Service Bulletin

Bulletin No.: 13-06-01-003D

Subject: Excessive Oil Consumption – Perform Oil Consumption Test and/or Install Piston and Piston Ring Kit

Models: 2010-2013 Buick LaCrosse
2011-2013 Buick Regal
2010-2013 Chevrolet Equinox
2012-2013 Chevrolet Orlando (Canada Only)
2010-2013 GMC Terrain
Equipped with 2.4L Engine (RPOs LAF, LEA)

Acceptable Cylinder that Does Not Appear Uniform (Zebra Stripes)

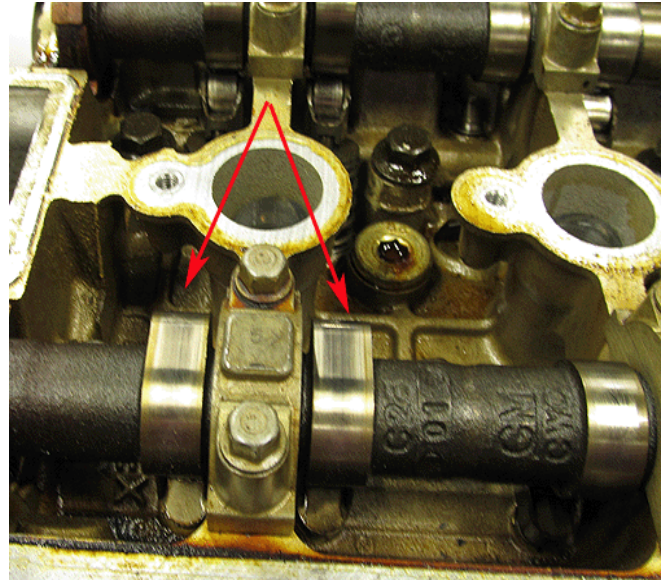
The repair is to replace the pistons and rings. In some cases the bore surface may not have a uniform look to the finish (zebra stripes) as shown below. As a result, some technicians may question whether the engine should be repaired or replaced. After careful evaluation, GM Powertrain has determined that the new pistons and rings will perform correctly in bores that have this appearance so engine replacement should not be

necessary. The cylinder bores do not need any machine or honing work performed on them. Refer to the picture below for acceptable surface finishes.

3409678

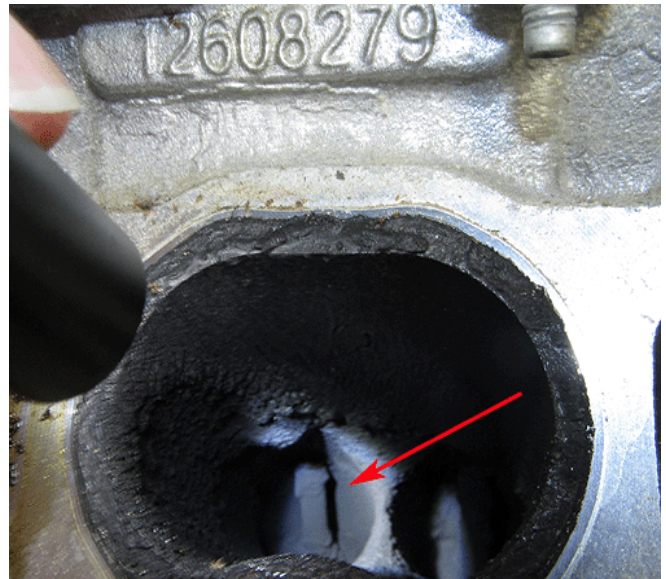
- Camshafts and roller follower will have wear markings. This is normal and do not need to be replaced (refer to picture above).
